Greenville Utilities Commission
Greenville, North Carolina
Questions and Answers I for RFB 22-20, Due 03.31.2022 at 3:00 pm

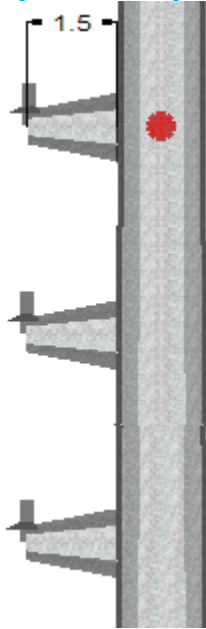
8. Caisson diameters are listed as preliminary on structure list, can we take these listed preliminary caisson diameters as min. required diameters?

Answer: Yes, this is the minimum caisson diameter at the provided length. This is based on our best estimate and the maximum base moment. If the caisson diameters are smaller than what the vendor has for structure diameter, the caisson diameter can be increased. Vendors should note any change to caisson diameters in their bid.

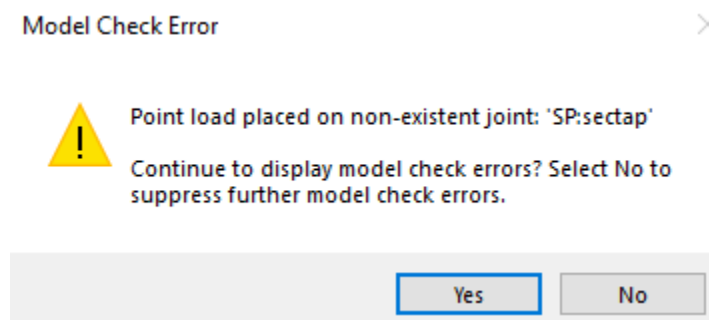
9. We don't have drawings for WPE structures, some WPE .pol files have davit arms (ENG-DE-DistJumper Bracket) that , we believe GUC is procuring from other sources and is out of scope for this bid. If we have to provide these arms then GUC needs to provide loading to design these arms. We are unable to verify structural adequacy of WPE class poles selected by GUC. Meyer quote will be based on WPE class selected by GUC.

Answer: These davit arms will be procured by GUC and is out of the scope for this bid.
